## ADDENDUM #001

DATE: MAY 3, 2024

ELKHORN PUBLIC SCHOOLS  
ELKHORN HIGH SCHOOL  
AUDITORIUM RENOVATIONS  
1401 VETERANS DRIVE; ELKHORN, NEBRASKA 68022

JJA PROJECT: 3626  
DRAWINGS & SPECIFICATIONS  
DATED: 04/15/2024

1  
E1.1  
LEVEL ONE LIGHTING AND FIRE ALARM RCP  
3/16" = 1'-0"

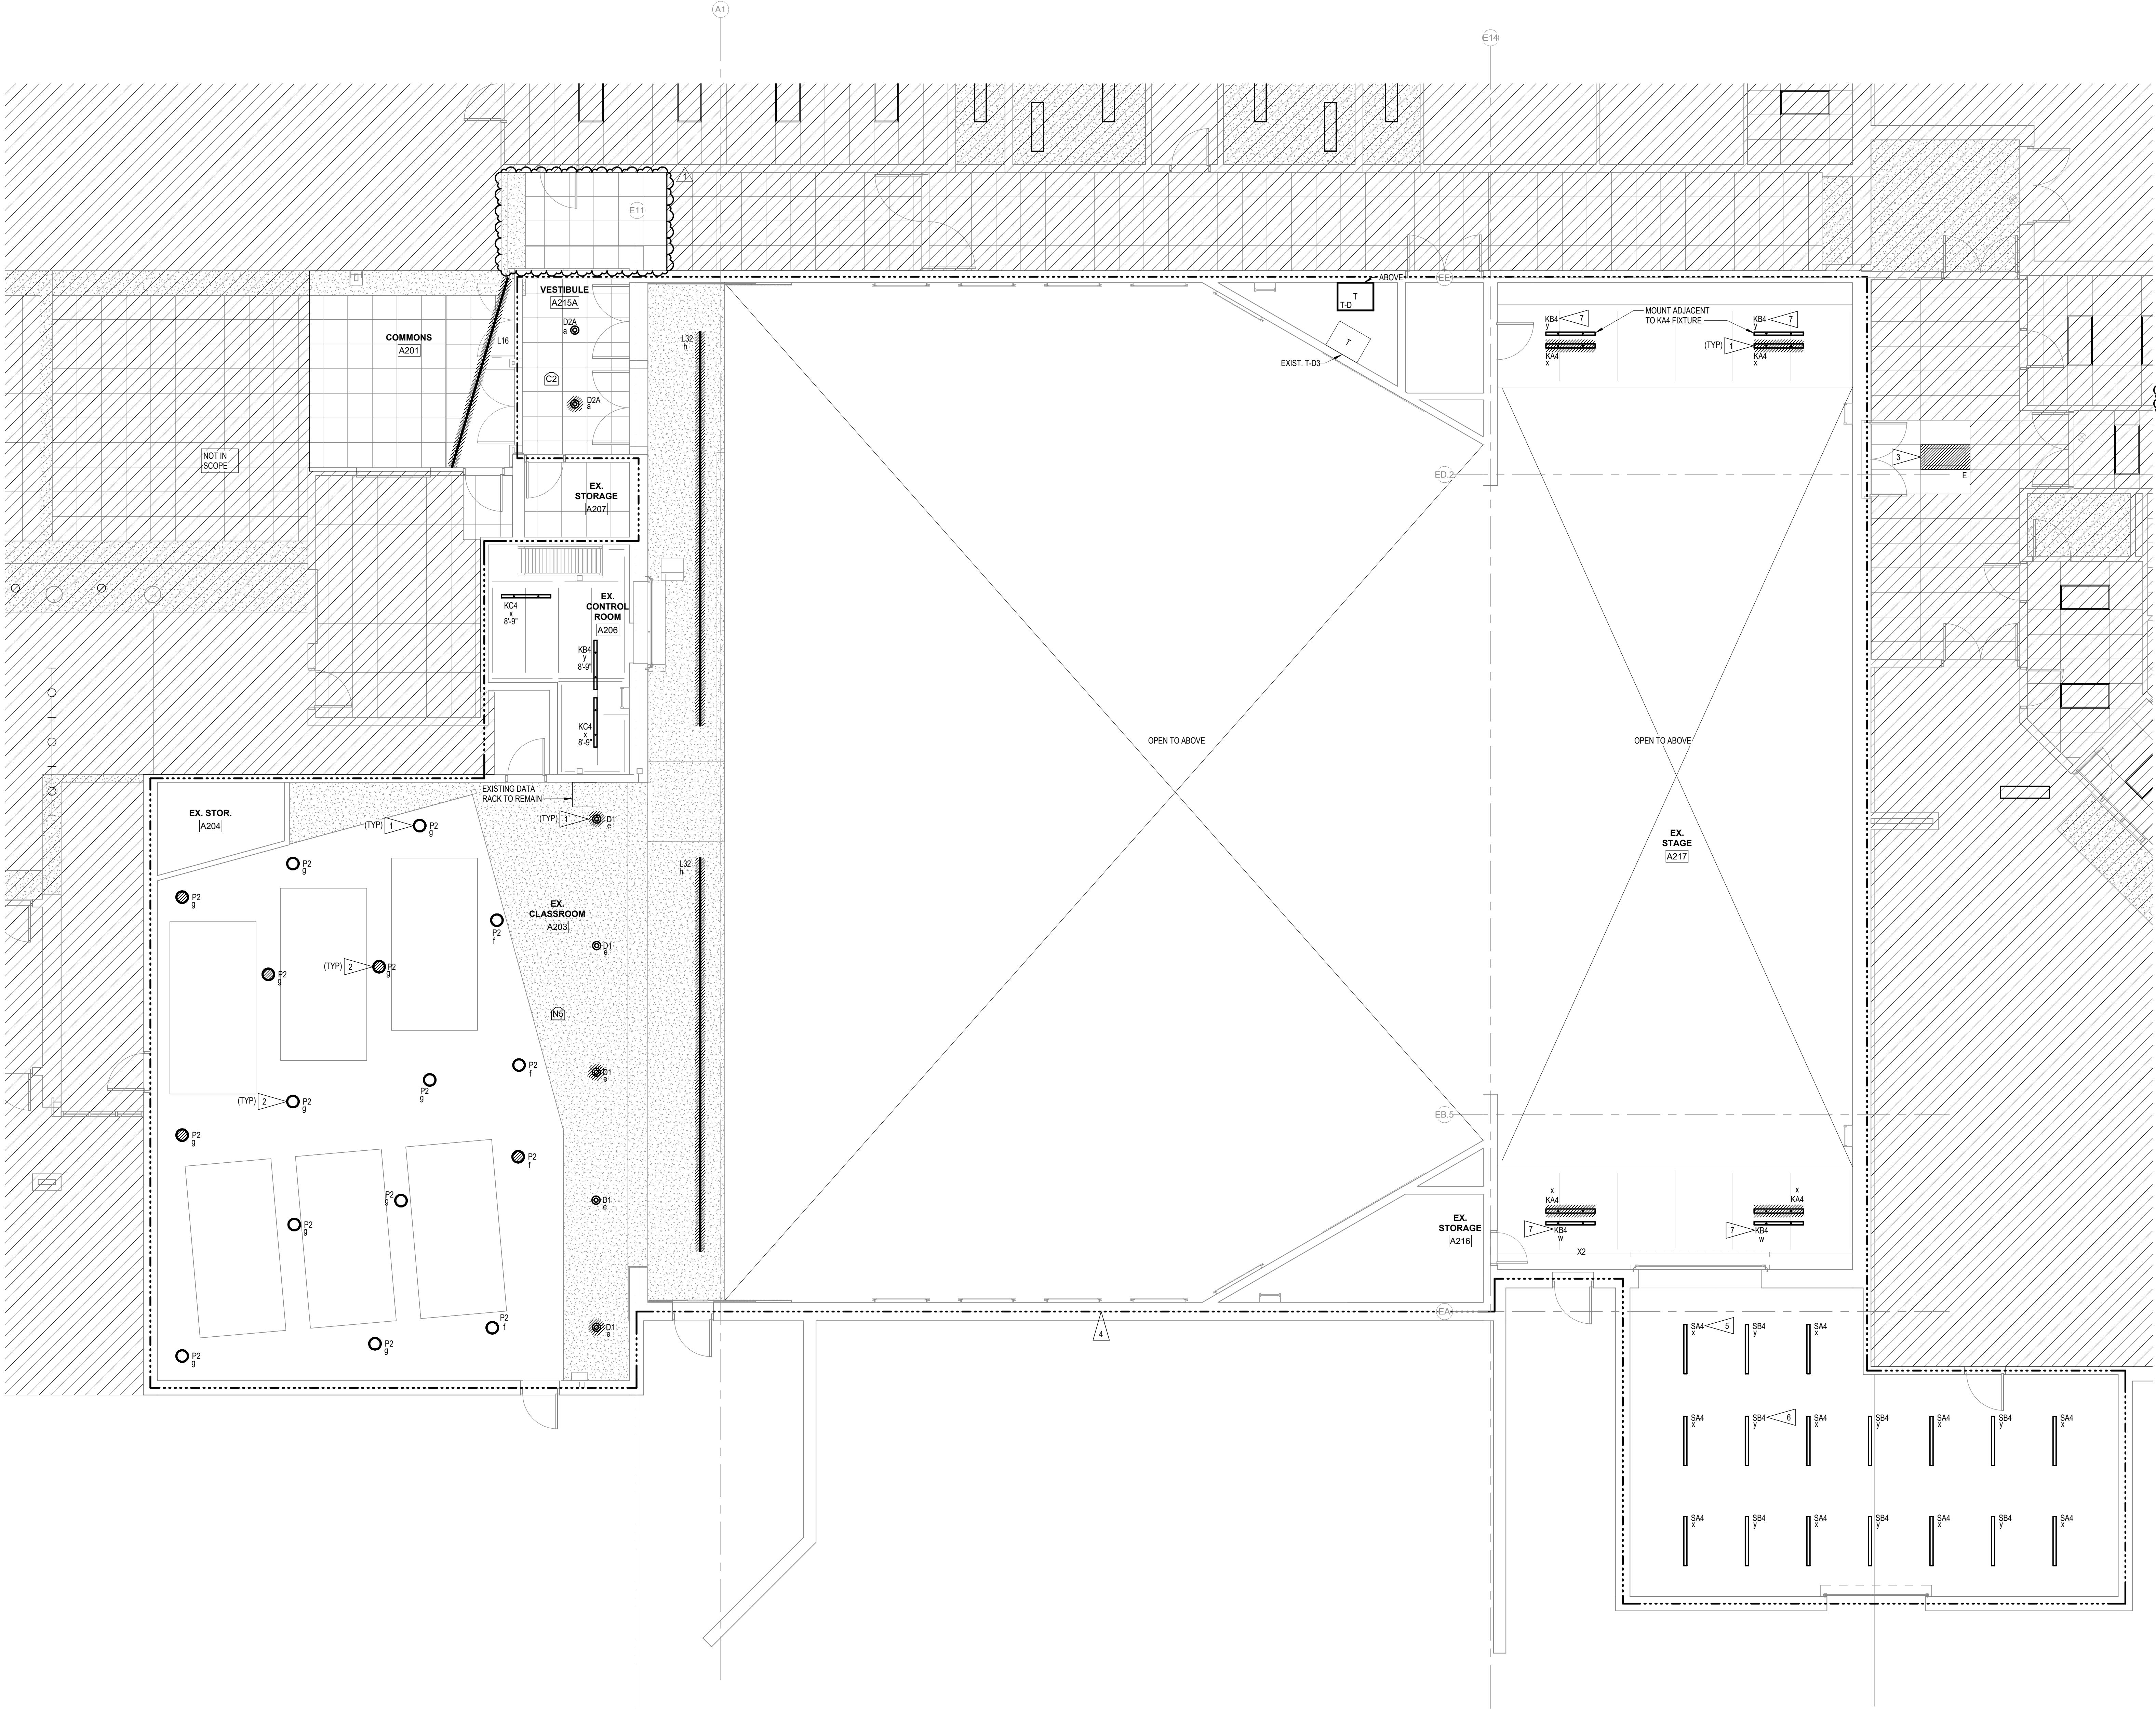
- Item #14**      Refer to Drawing E1.0 – Level One Lighting Floor Plan and attached revised sheet.  
A. ADD – Note to clarify mounting location of T3 fixture.
- Item #15**      Refer to Drawing E1.1 – Level One Lighting Reflected Ceiling Plan and attached revised sheet.  
A. REMOVE – Wall wash fixtures in existing hall.
- Item #16**      Refer to Drawing E2.2 – Level Two Power Floor Plan and attached revised sheet.  
A. REVISE – Callout for fire rated door closer.
- Item #17**      Refer to Drawing E6.0 – Electrical Schedules and attached revised sheet.  
A. ADD – Alternate manufacturers to luminaire schedule.
